Staff Report

To: BOZAR
From: Jessie Earley, Senior Planner
Meeting Date: BOZAR, February 24, 2026
RE: Work Session: Mock Review Gunnison County Model Plans

PROJECT TITLE: Work Session: Mock Review Gunnison County Model Plans

Sample Rendering
 This rendering shows an example of how a modern home may be achieved with this document. Exterior materials shown here are vertical ship-lap MFC siding, horizontal corrugated metal panel, and standing seam metal roof.

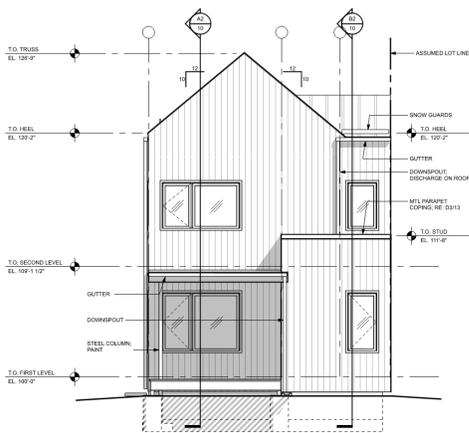
GL	Staff Analysis
4.33-4.34	<p>Consideration of whether the forms achieve relationships with historic buildings are in GL 4.33 and 4.34. 3D rendering is helpful to assess this.</p> <p>The flat module on the front elevation would likely be seen as excessively dissimilar.</p>
4.34 Discernable primary module	The front module, encouraged to be the discernable primary module is evident per GL 4.34 b.

B1 FRONT ELEVATION
SCALE 1/4" = 1'-0"

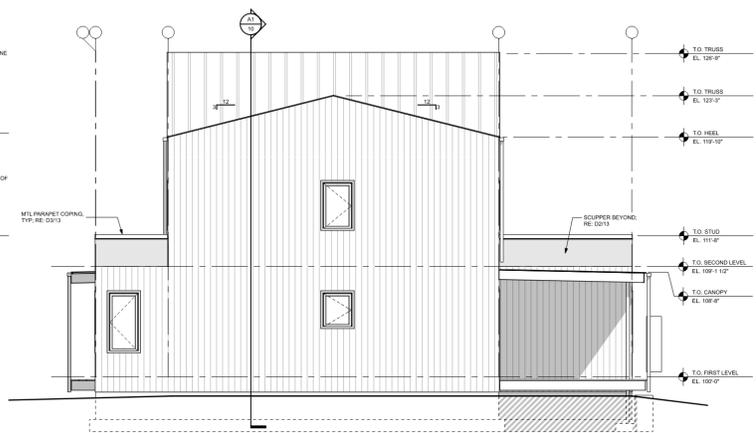
4.39 Additons	NA
4.40 Duplex	The design is consistent with the GL, which asks for it to be seen as a single family home. However, the building would need to be varied for the second entry to prevent what the GL describes as a mirror image.

GL	Staff Analysis
4.49 Covered porches	The entry porch on the front is a flat roof entry, which is prohibited by GL 4.49a.
4.50 Mix of porch styles	The entry porch measures 10'10" x 8'1" at its shallowest depth, which complies with the intents of GL 4.50 b encouraging a depth of at least four feet.
4.51 Rear porches	The rear porch is simple 6'2"x12'1". Again, the flat roof is discouraged.
4.52 Second and third story decks	The second story elevated deck is located on the rear side of the property and meets the intent of GL 4.52. There is a second, second story deck facing the street which would not meet the intents of GL 4.52. Both decks propose a pony wall as opposed to a railing feature, which appears dissimilar.

GL	Staff Analysis
4.53 Window to wall ratio	Window to wall ratios along the front elevation proposes 72.56 sf of glazing/ 478.45 sf wall space, which is 15% window to wall. This is in line with the 10-20% that is generally seen. Additionally, this is a new zone. The first floor presents one two pack and a single window (40.8 sf), there is one single window and a two pack on the second floor (32.76 sf). Support

B2 RIGHT END ELEVATION
SCALE 1/4" = 1'-0"

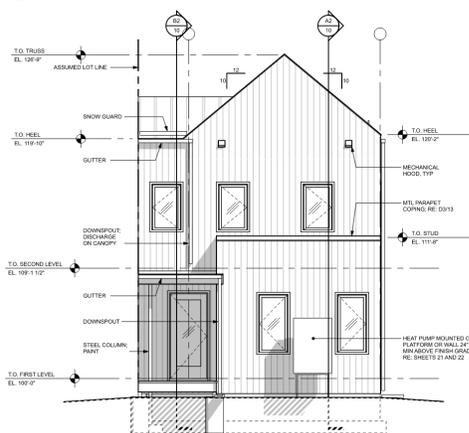
<p>The right end elevation proposes two single windows on the first floor and one single window on the second floor.</p> <p>The rear elevation proposes two single windows and a full light door on the first floor and three single windows on the second floor.</p> <p>The left end elevation proposes a single window and full light door on the first floor and a single window and a full light door on the second floor. The second floor door is obscured by the wall of the building.</p>

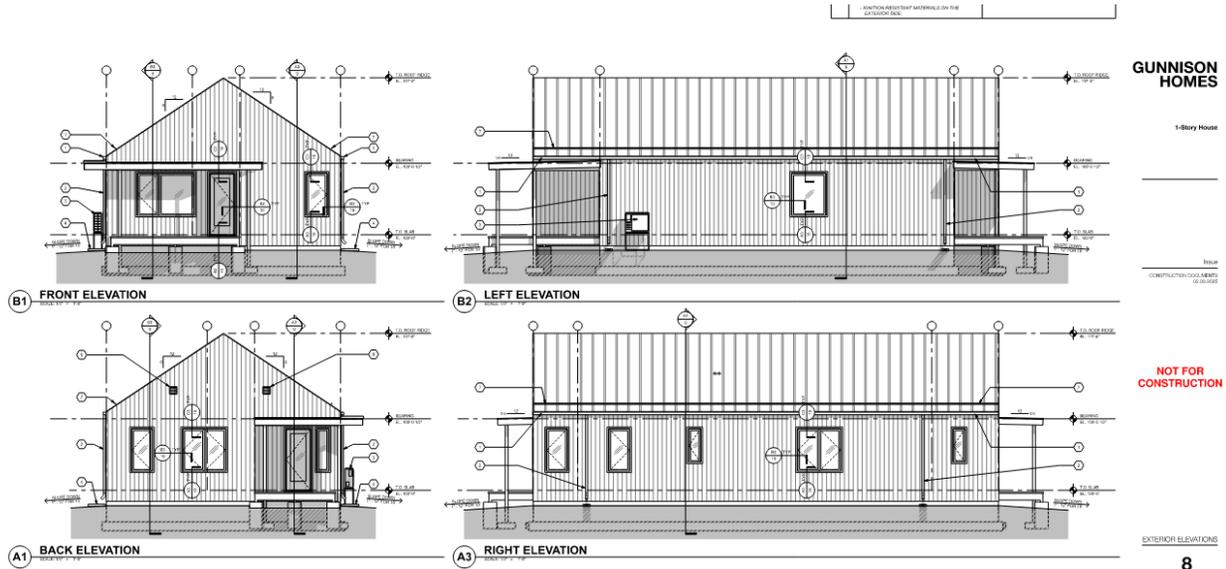
GL	Staff Analysis
4.84 Smaller in size	The proposed building is smaller in scale than the primary building, as requested by the GL. However, the sf would need to be reduced to comply with our zoning requirements. This could likely be done through a roof pitch change and reduction in porch sizes.
4.85 Rear of the site	NA
4.86 Vary appearance	This is a simple structure, which is supported by the GL and is varied to other ADU's as seen in town.
4.89 d. porches	There are covered porches on the front and rear. The flat roofs are not supported, as proposed.

GL	Staff Analysis
4.53; 4.88 fenestration	<p>There is a two pack, single window and door glazing on the front elevation. This glazing is all located on the first floor. There is 60.17 sf of glazing/391.94 sf of wall space, which is 15.4%.</p> <p>There is a single window on the left elevation</p> <p>There is a two pack and four single windows on the right elevation.</p> <p>The rear elevation proposes two single windows a two pack and door glazing.</p> <p>Windows would not be supported, as proposed as full light and would need to incorporate divided lights.</p> <p>The window on the rear adjacent to the door appears to be a side light, which are not allowed by the GL</p>
